**NOTICE OF HEARING  
OPEN TO THE PUBLIC  
DEVELOPMENT APPEALS BOARD**

<b>Pages</b>
<b>1. Appeal 14-2019 - Development Permit Denial - 221 10th Street East</b>	<b>2 - 17</b>
New One-Unit Dwelling

**Re: Development Permit Denial  
221 10<sup>th</sup> St E  
New One Unit Dwelling  
R2: One and Two-Unit Residential District**

SITE PLAN

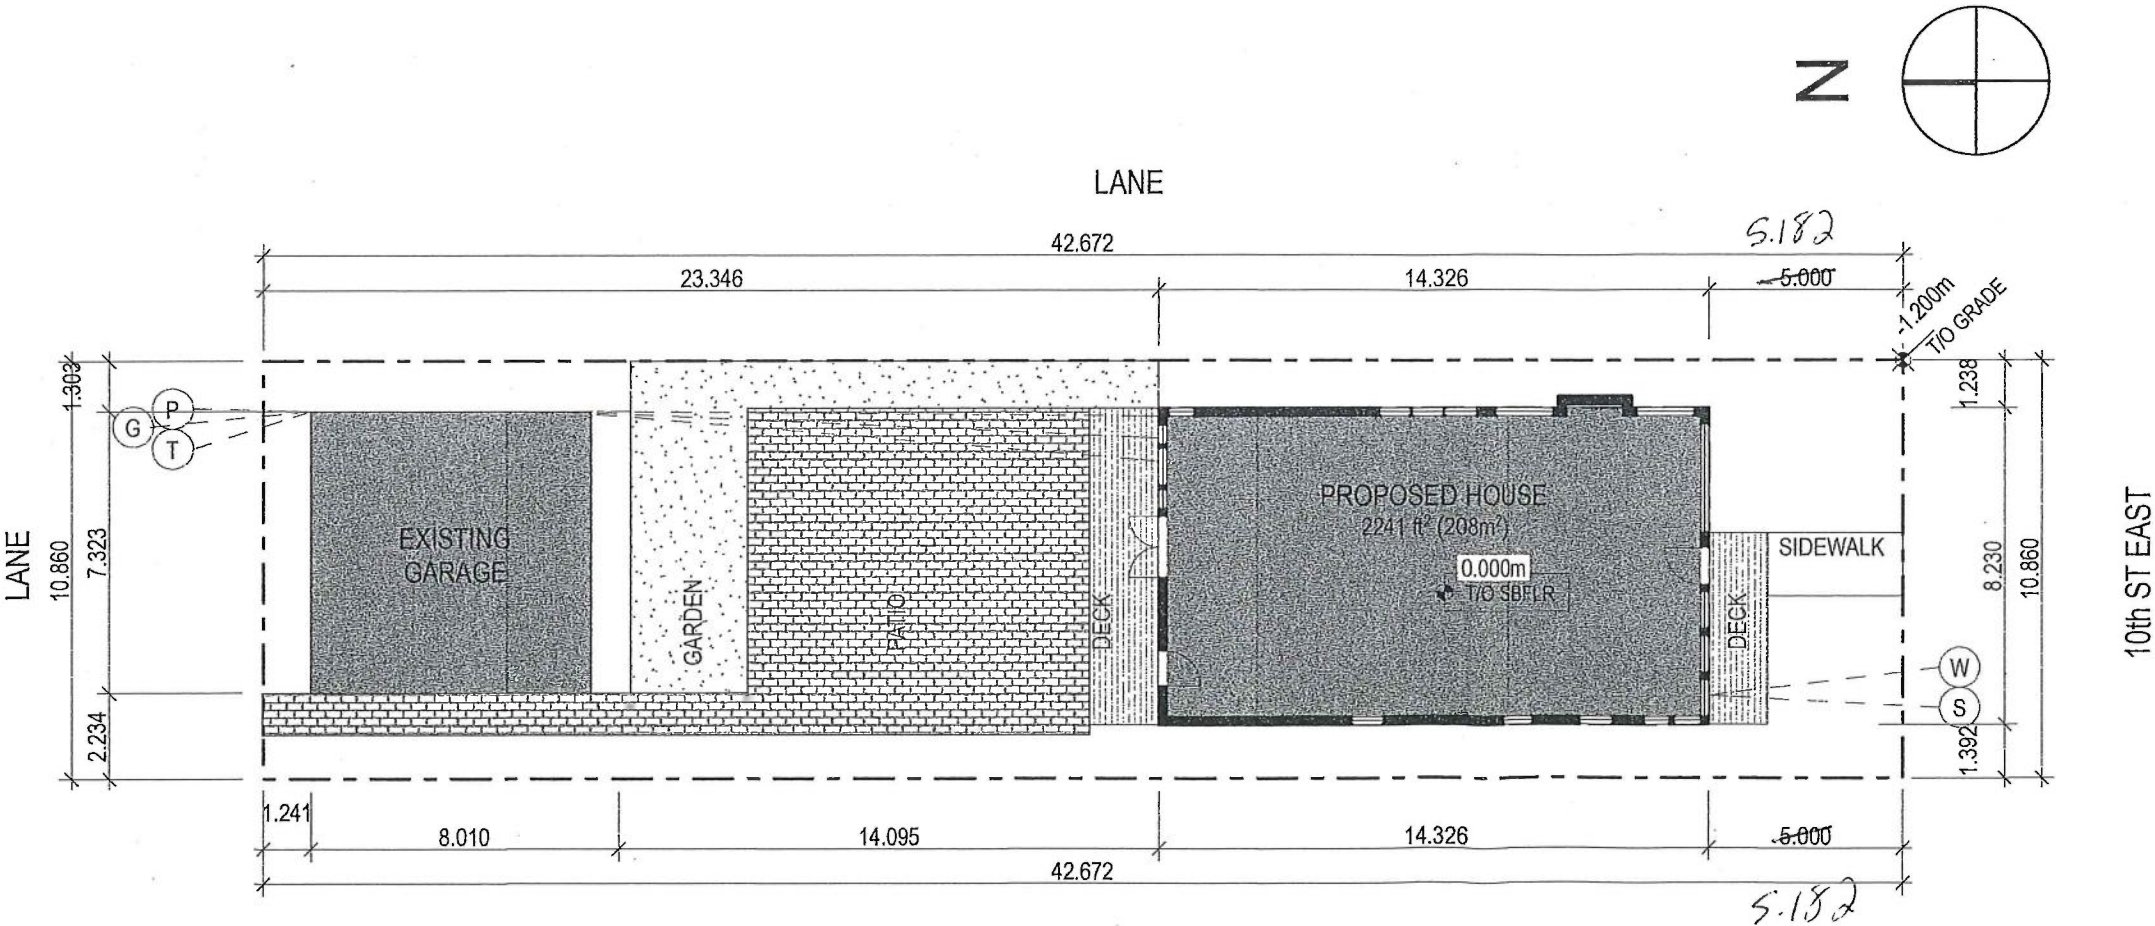
- 1) Requirement: Section 8.4.2(1) states that the minimum front yard setback for a One Unit Dwelling is 6 meters.

Proposed: The proposed one unit dwelling has a front yard setback of 5.182 meters.

Deficiency: The proposed one unit dwelling will create a front yard setback deficiency of 0.818 meters.
